Essential Clothing Ltd. (Nagchala Campus)

23 April 2026

1. Building Information

2. Observation

Observation-03: Possible falling hazard at loading unloading platform. (Production Building)

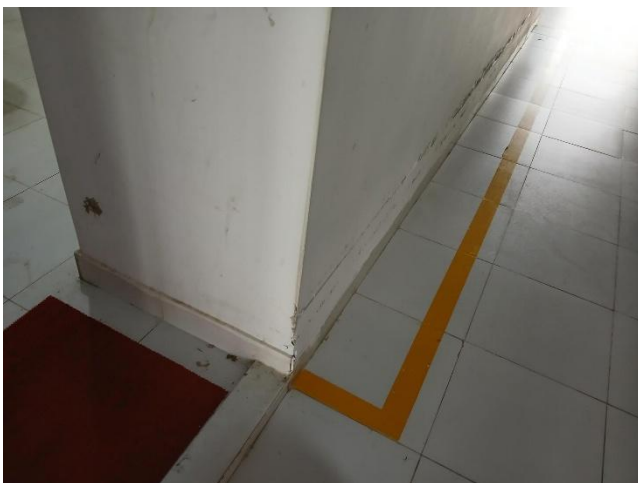
Description: No barrier was found at elevated platform of loading unloading zone. Building engineer is required to provide barrier/railing to the elevated platform to mitigate the falling hazard.

5.	Possible falling hazard at the loading and unloading platform. (Production Building)	The building engineer is required to provide a suitable barrier/railing to the elevated platform to mitigate the falling hazard.	within 6 weeks

Figure 3.1-1: 3D View of the Analytical Model

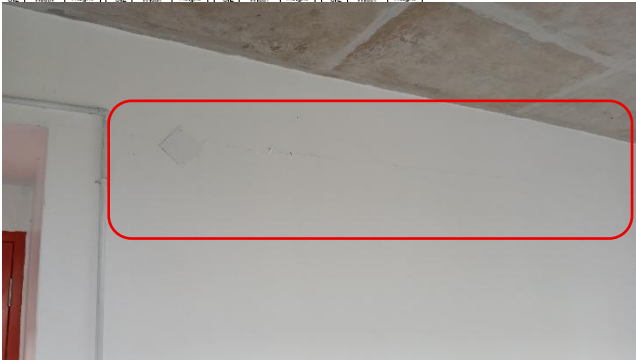
Description: The building engineer has prepared the design report for the dining building. however, the factory is required to submit the complete design documents to RSC for detailed review.

9.	Prepared design report needs to be reviewed against lateral loading (Dining Building)	The factory is required to submit the complete design documents to RSC for detailed review.	within 6 weeks

Observation-08: Crack on beam and brick wall joint (Dining Building)

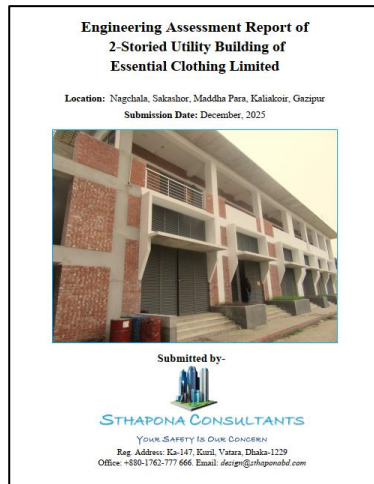
Description: Cracks were observed on the beam and the brick wall joint and brick wall at stair roof. The building engineer is required to investigate the reason for the crack and repair it with a suitable method.

10.		Carry out suggested remedial works if required.	within 6 months
11.	Crack on beam and brick wall joint (Dining Building)	The building engineer is required to investigate the reason for the crack and repair it with a suitable method.	within 6 weeks

**Design Report on
Car Parking Shed with STP of
Essential Clothing Limited**

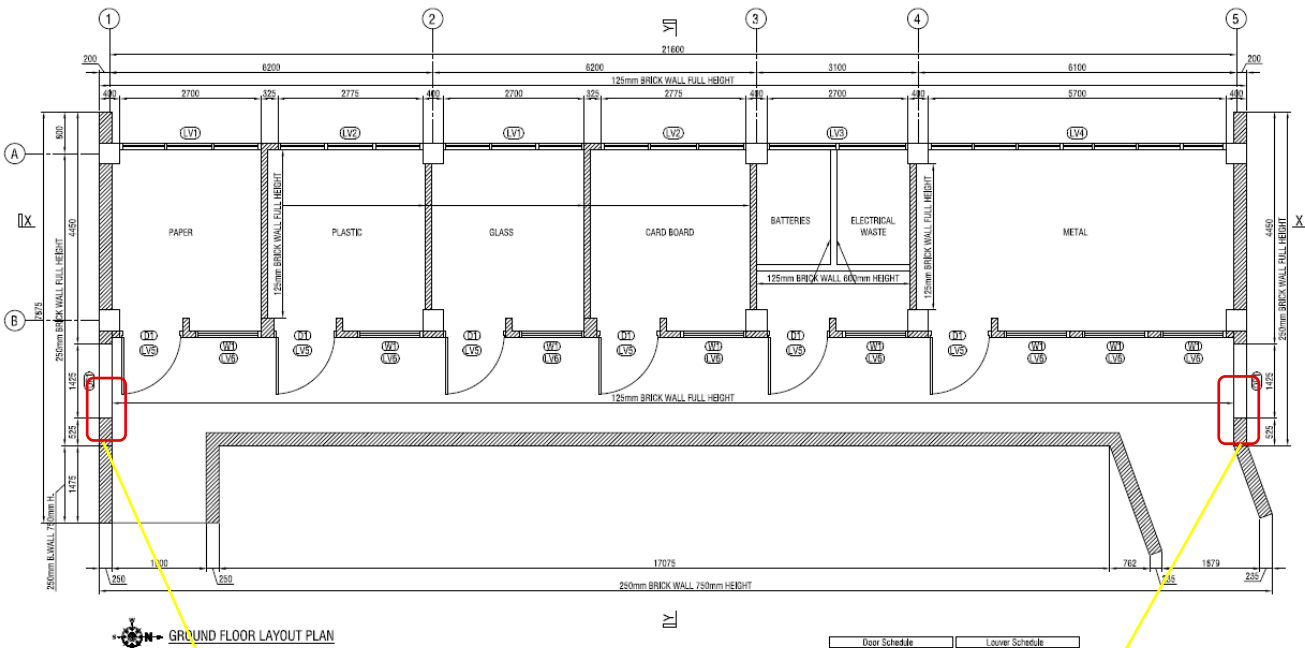
Description: During the inspection, the Engineering Assessment (EA) report was found on-site as per BNBC 2020, and the following observations were noted:

- Factor of safety (FoS) check for the single footing was not provided.

The building engineer is required to address all the inconsistencies in the revised EA report as per 1.9.1 BNBC and submit to RSC.
